PWR Small Break LOCA Evaluation Model, S-RELAP5 Based

EMF-2328(NP)(A)
Revision 0
Supplement 1(NP)(A)
Revision 0

**SUBJECT: FINAL SAFETY EVALUATION BY THE OFFICE OF NUCLEAR REACTOR
REGULATION FOR TOPICAL REPORT EMF-2328(P)(A), REVISION 0,
SUPPLEMENT 1, REVISION 0, "PWR [PRESSURIZED WATER REACTOR]
SMALL BREAK LOCA [LOSS-OF-COOLANT ACCIDENT] EVALUATION MODEL,
S-RELAP5 BASED" (TAC NO. ME8227)**

TOPICAL REPORT EMF-2328(P)(A), REVISION 0, SUPPLEMENT 1, REVISION 0

Figure 1-25: Comparison of Primary and Secondary Pressures

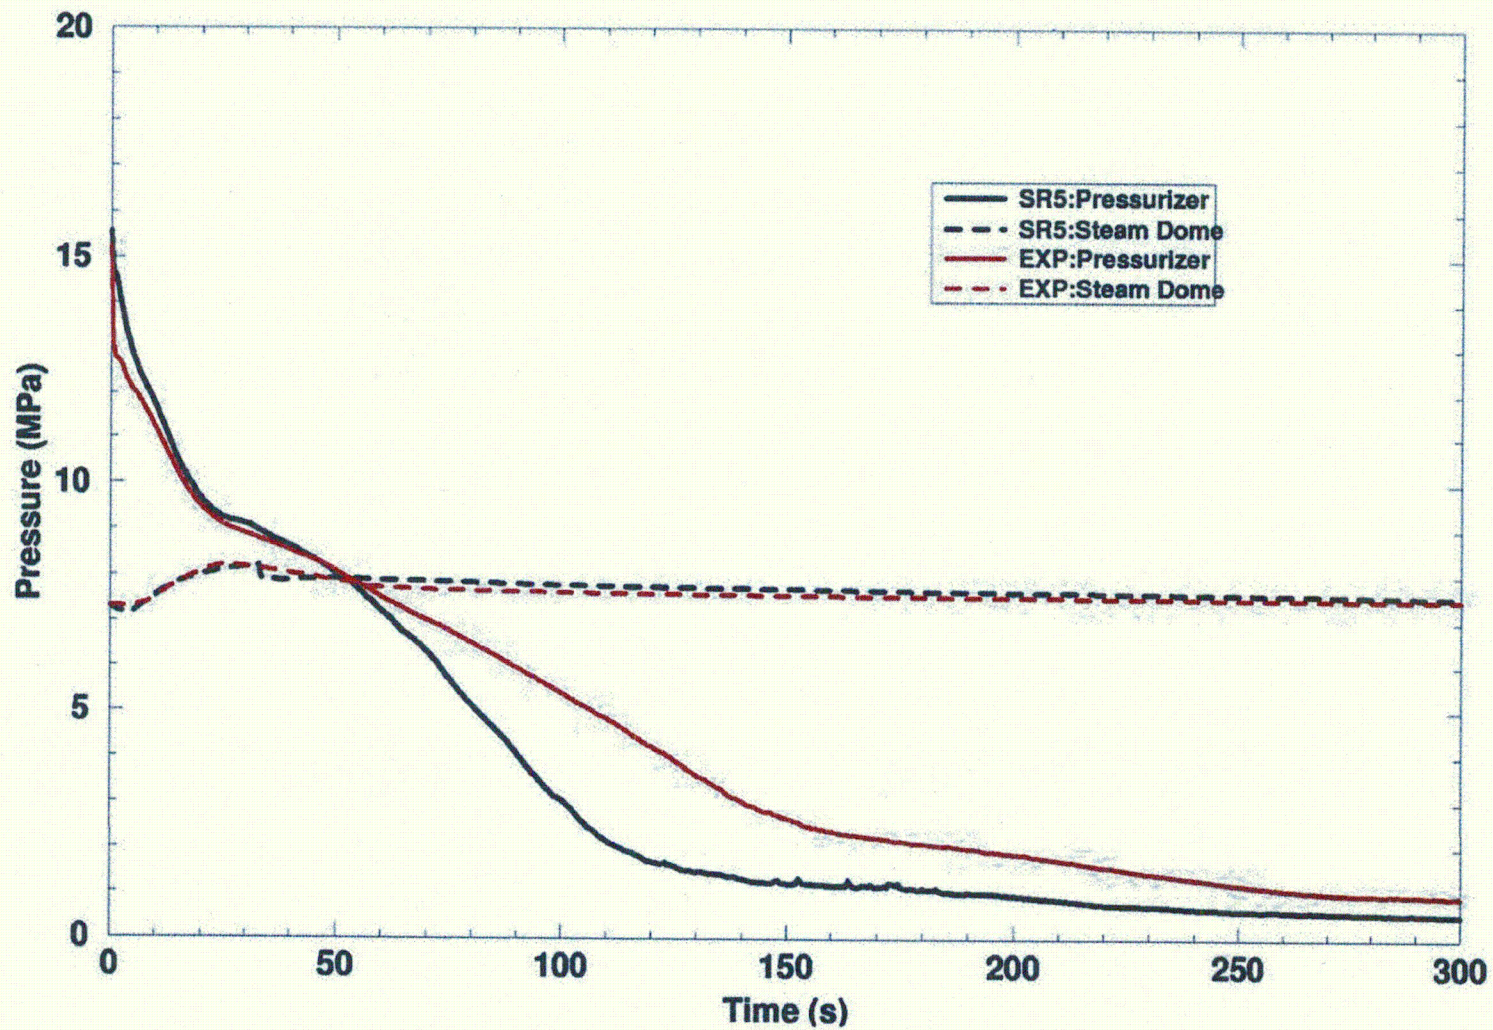
The experimental procedure for this test was to open the break at time 0.0, and then begin the power decay at approximately 10.0 seconds. Figure 1-25 compares the calculated primary and secondary pressure with that measured during the test. As shown in Figure 1-25, the relatively large break caused a rapid depressurization beginning at time 0.0, with an increase in the secondary side pressure after closure of the main steam isolation valves to about 8 MPa. After approximately 55 seconds, the primary dropped below the secondary pressure so that the secondary side no longer served as a heat sink. Until that time, S-RELAP5 did a reasonable simulation, but the calculated primary pressure decreased more rapidly than measured.

Figure 1-26: Comparison of Calculated and Measured Break Flow

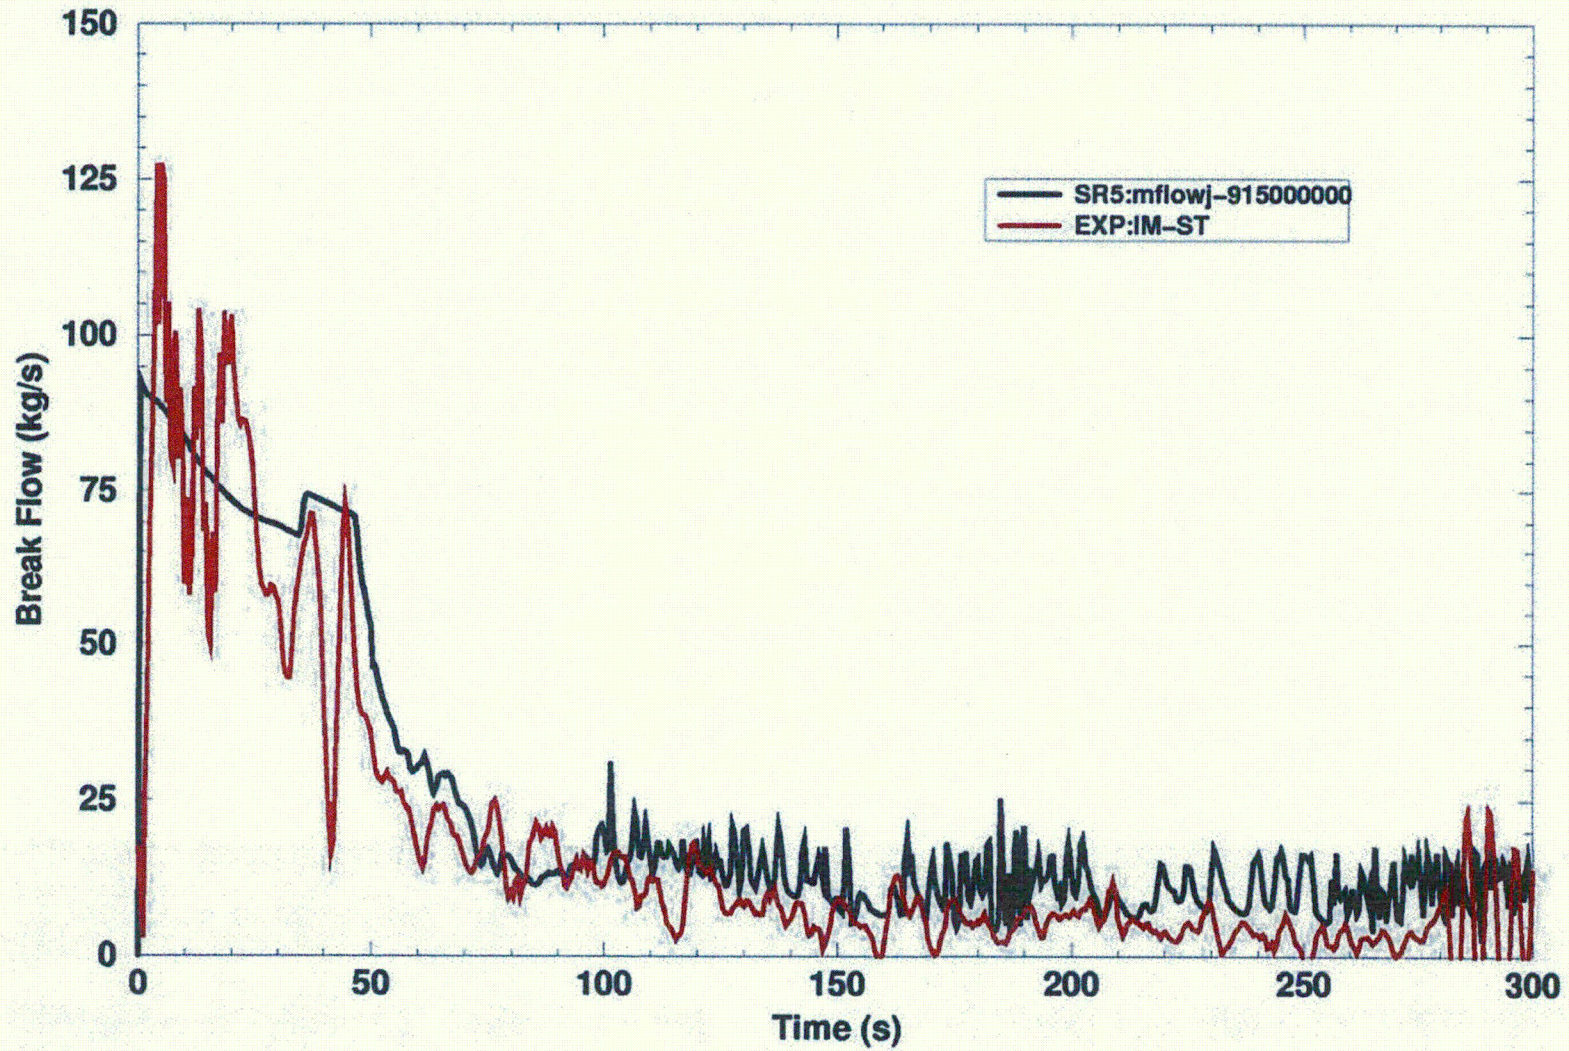
Figure 1-26 compares the calculated and measured break flow, and shows that S-RELAP5 simulates both the early liquid and the subsequent vapor flow reasonably well. The technique used in the ROSA-IV benchmark (RAI 1.1) of representing the break valve as being directly connected to the cold leg was not effective for this simulation. The break flow simulation improved when the S-RELAP5 model used [

Figure 1-27: Comparison of Measured and Calculated Peak Cladding Temperature

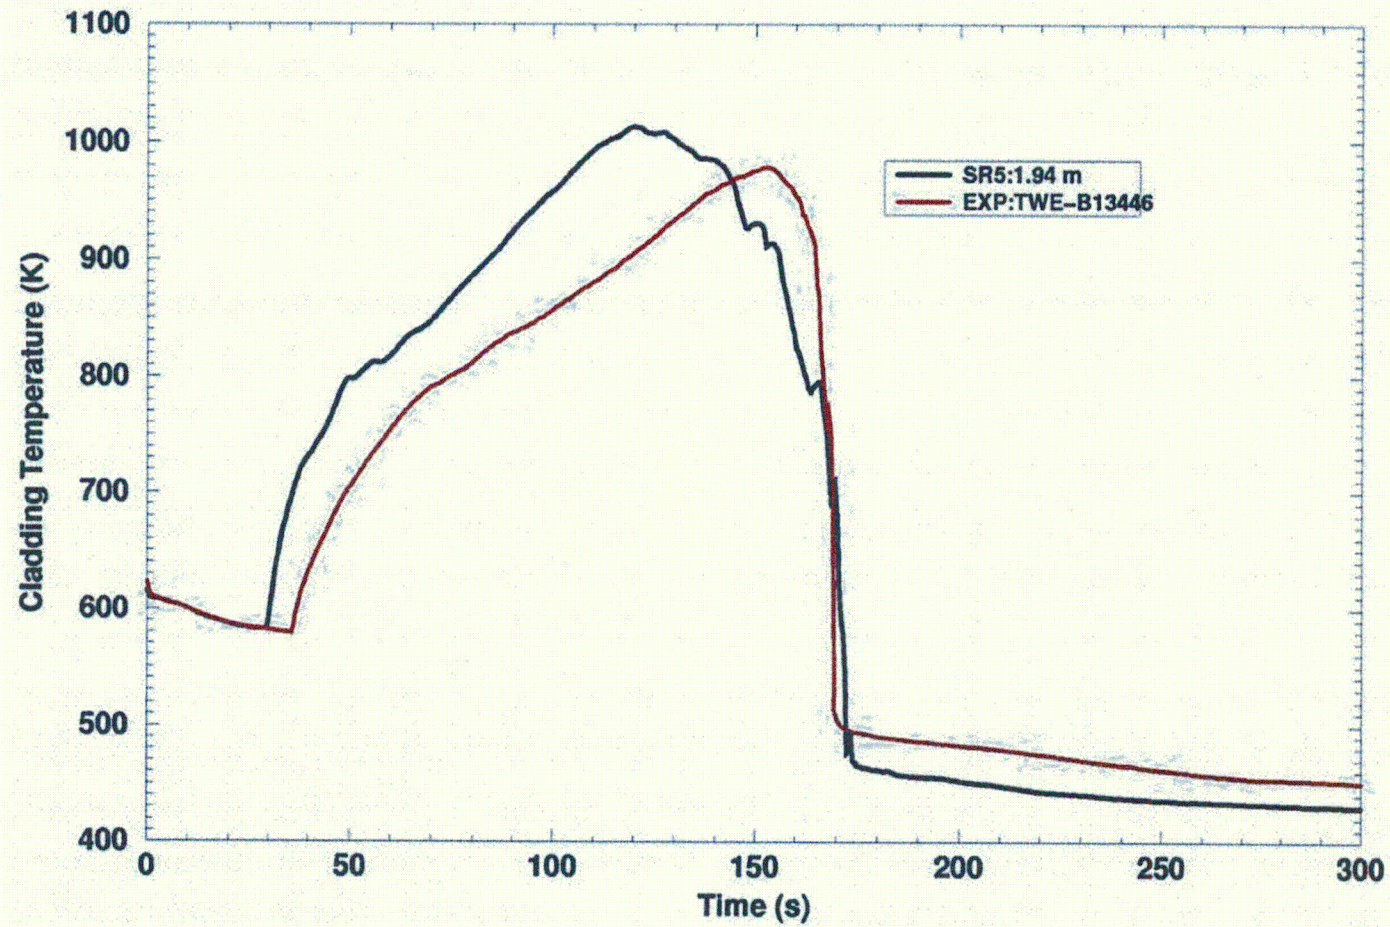
Figure 1-27 compares the peak cladding temperature (PCT) calculated by S-RELAP5 with that measured during test IB-CL-03. As shown in this figure, the calculation begins to heatup slightly early, and reaches its peak about 25 seconds before the test. The location of the PCT is also slightly lower, more closely matching the axial power profile. The high pressure injection (HPI) system was started at about 35 seconds, almost simultaneously with the core dryout, but was ineffective in both the experiment and calculation because the injection flow rate was much smaller than break flow rate. Accumulator injection during the test started at approximately 110 seconds, but was also ineffective in terminating the temperature excursion. As the S-RELAP5 predicted primary pressure during this time was slightly low, the code predicted the start of accumulator injection by 90 seconds, contributing to the slightly early turnaround of the calculated cladding temperature excursion. The test was terminated at approximately 150 seconds to protect the experimental facility when core temperatures approached 1000 K. At this time, the protection system for the facility decreased power and initiated full ECCS flow.

Figure 1-29: Steam Generator Differential Pressure in non-Pressurizer Loop

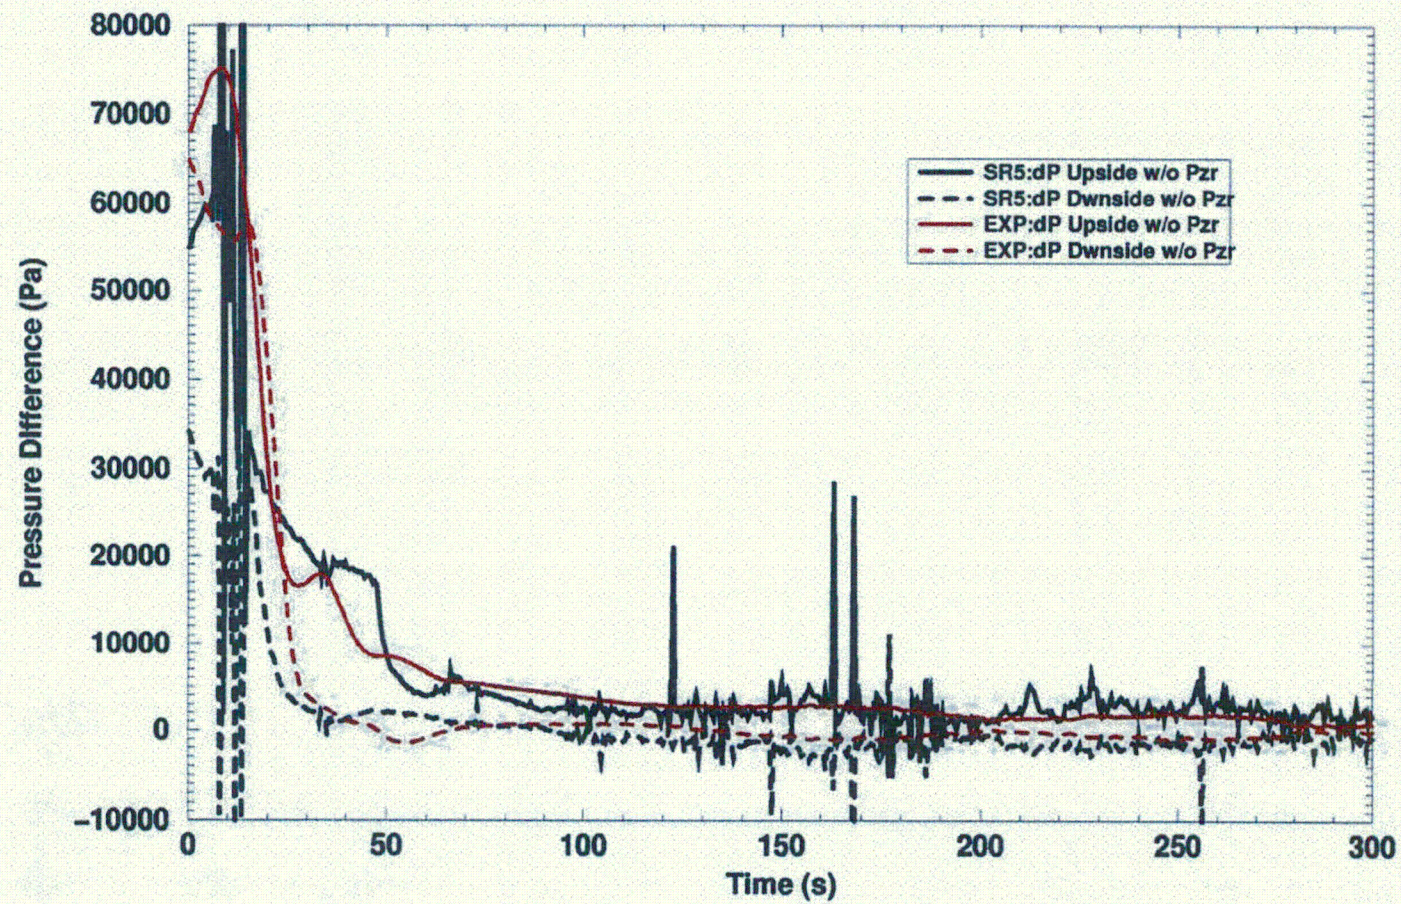
Figure 1-29 shows a similar trend for the differential pressure across the steam generator in the loop without the pressurizer. Once again, S-RELAP5 predicts that CCFL will retain more coolant than measured in the steam generator tubes, with the liquid draining back into the hot leg after approximately 50 seconds.

Figure 1-30: Pressure Differential across the upper plenum

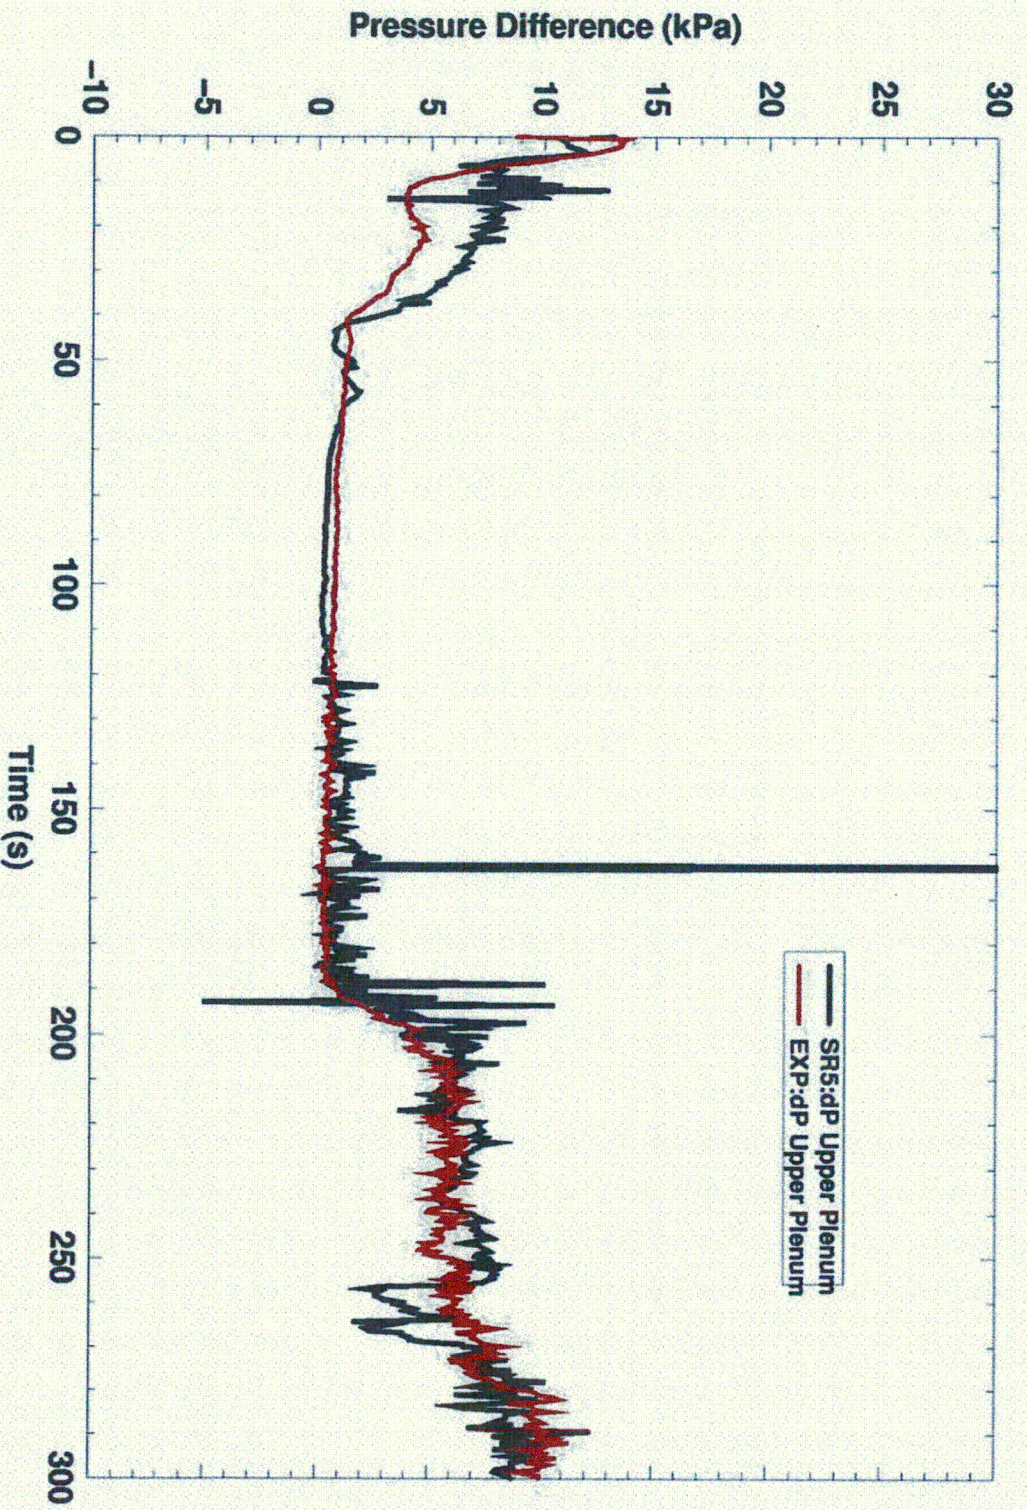
The calculated and measured pressure differential across the upper plenum is compared in Figure 1-30. As shown in this figure, the test showed a pressure differential prior to 40 seconds, indicating a mass of water is being held above the upper core plate by CCFL. The measured data indicates this water is swept to the hot legs. The S-RELAP5 model also predicts that the liquid is held above the core until about 40 seconds, but then predicts that the liquid in the upper plenum drops into the core region.

Figure 3-3: Comparison of Cold Leg Pressure for the L3-6 Test

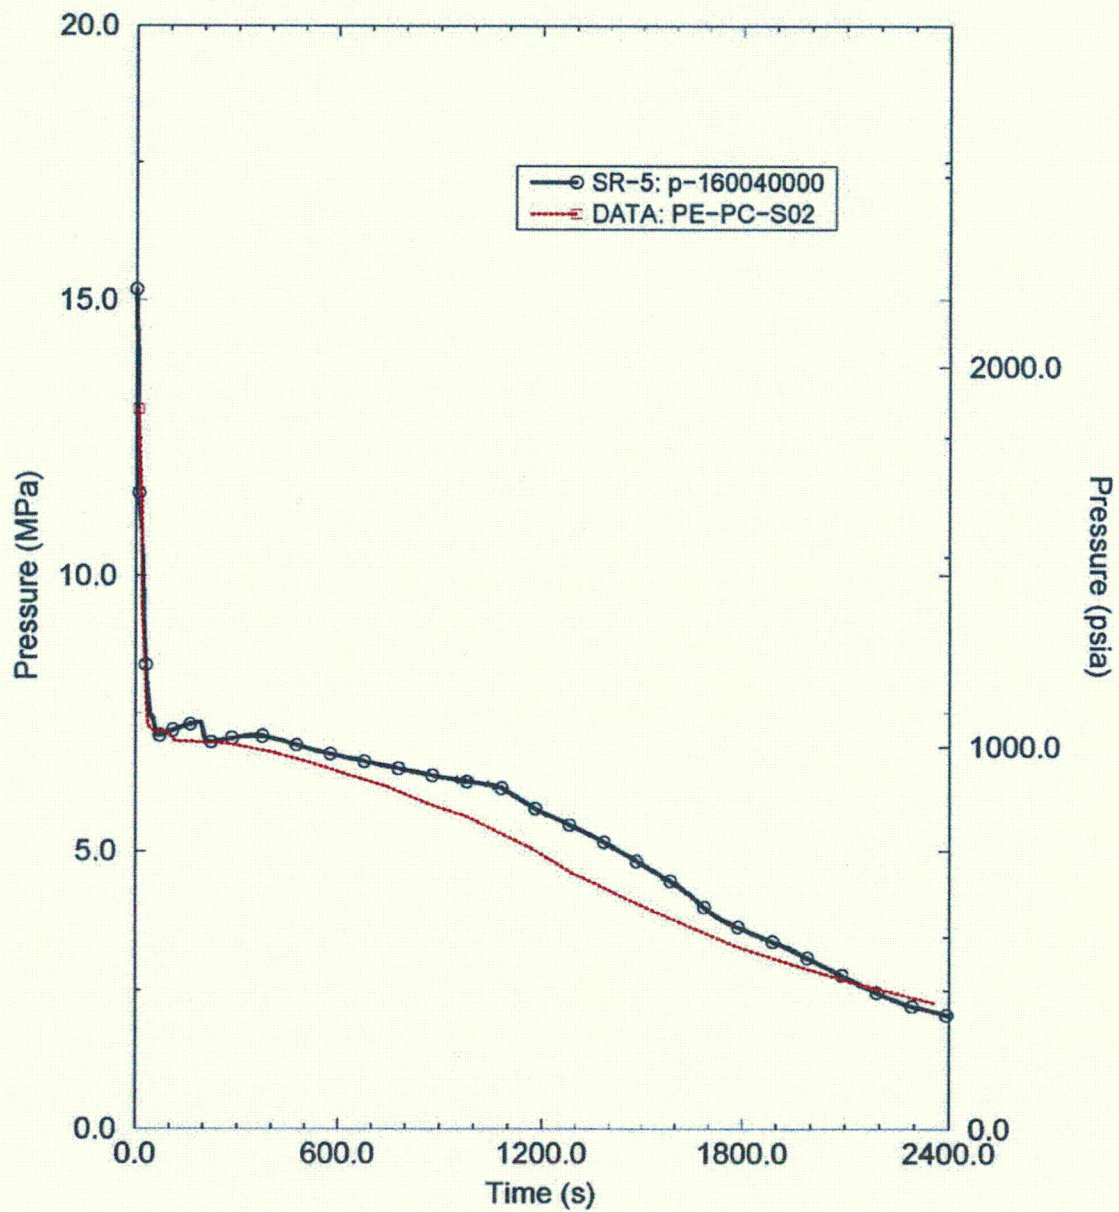
Figure 3-3 compares the calculated and measured pressures in the intact loop cold leg. The calculated pressure compares well with the test data. The code predicts a slightly higher pressure between 600 and 1700 seconds, but it converges with the measured data at the end of the test.

Figure 3-4: Comparison of Break Mass Flow Rate for the L3-6 Test

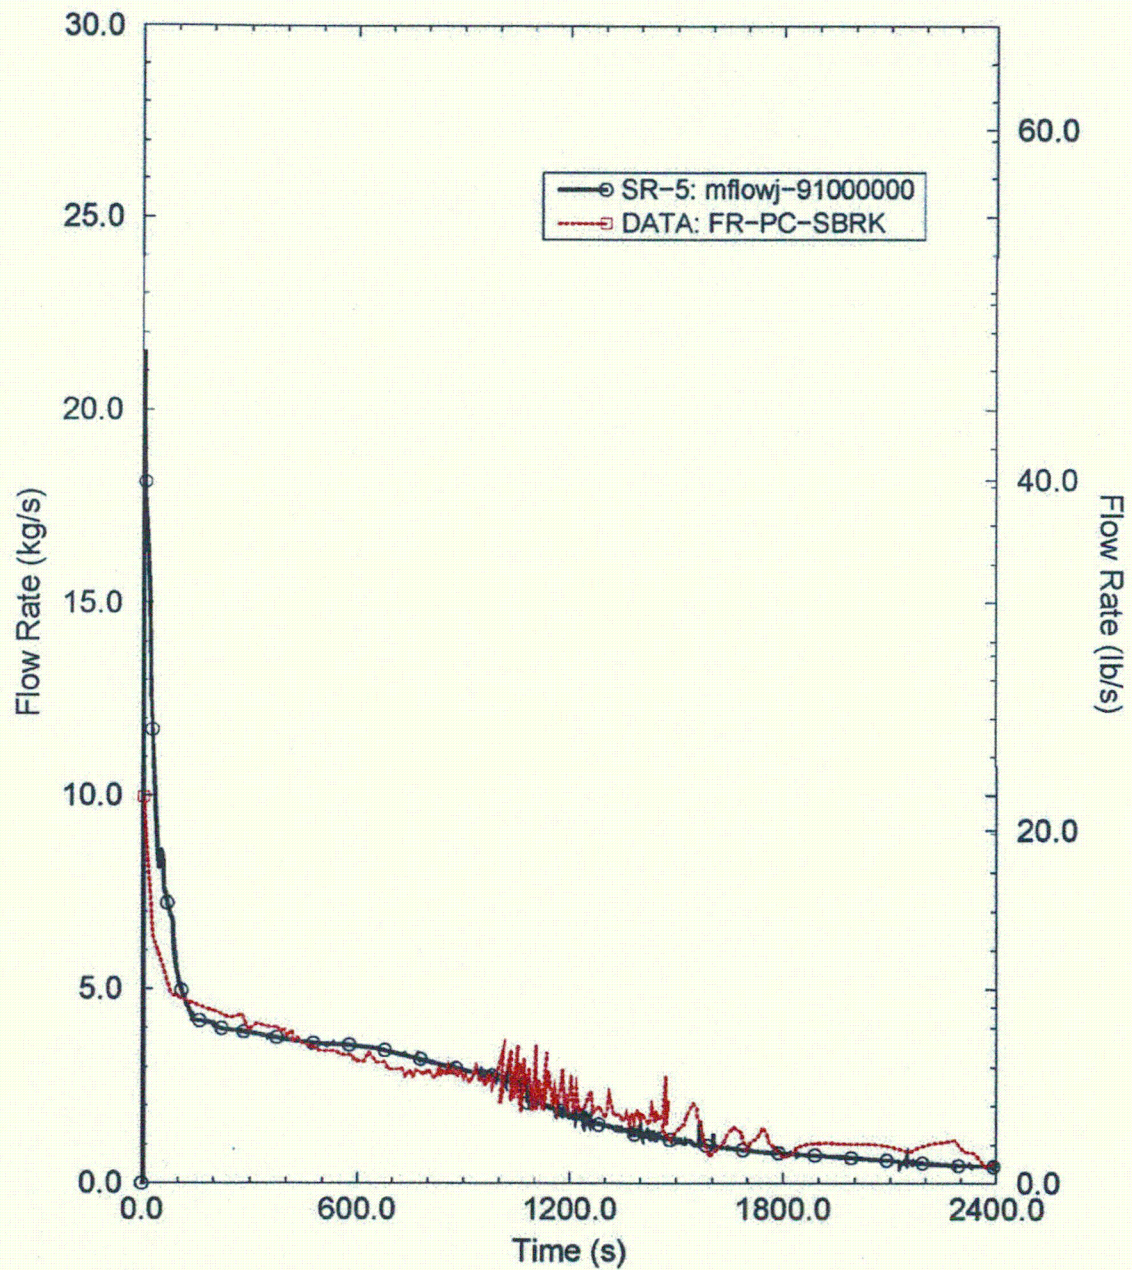
The break flow rate prediction (Figure 3-4) shows good agreement with the measured data and the predictions are within the data uncertainty band of 15 percent for 50 to 1435 seconds and ± 0.75 kg/s for 1435 to 2400 seconds.
